STATE OF NORTH CAROLINA  
DEPARTMENT OF TRANSPORTATION

**Addendum No. 2**

RE: Contract # C205165

SITES 936-940, 942-944, 314, 316-321, 941: US-176 FROM 0.1 M N OF THOMPSON RD TO 0.8 M EAST OF BEAR CREEK LN. W03293

REVISIONS						SHEET NO. W-7
NO.	BY	DATE	NO.	BY	DATE	
1	KND	03/26	3			
2			4

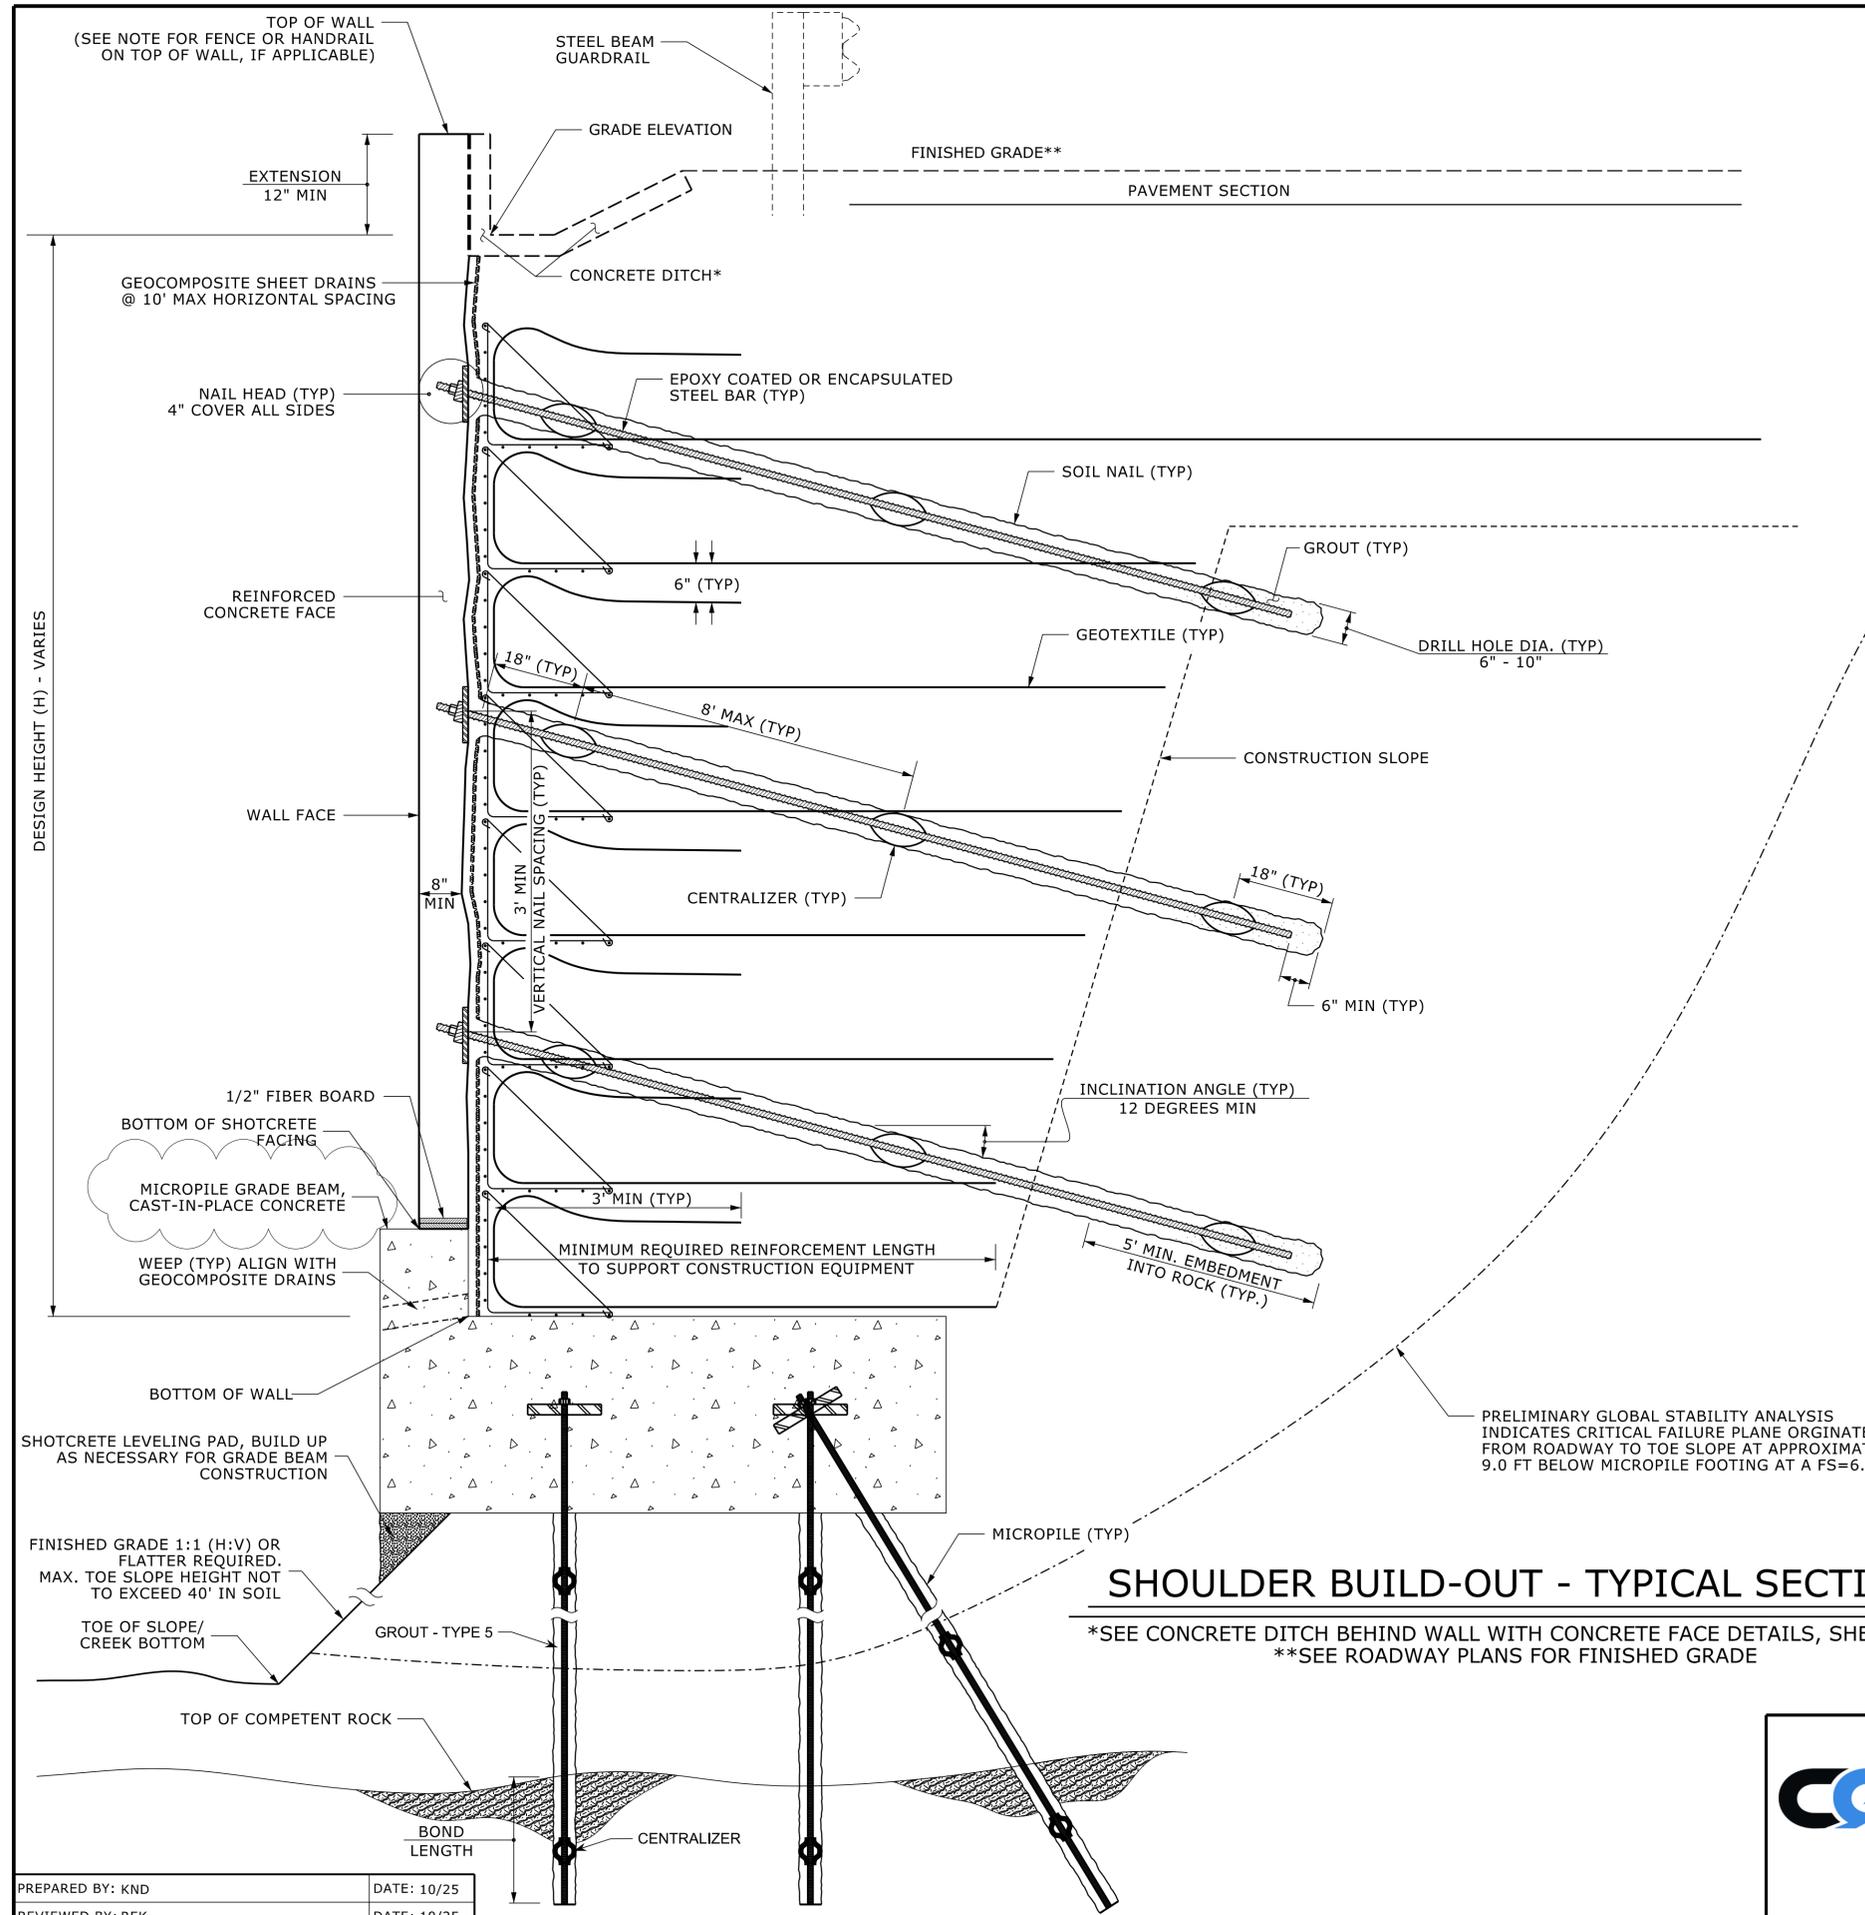
Sheet No.	Revision
W-5 (Part 1), W-7 (Part 1), W-7 (Part 2), W-9 (Part 2), W-13 (Part 2), W-17 (Part 2)	Revised call-out to read “MICROPILE GRADE BEAM, CAST-IN-PLACE CONCRETE”
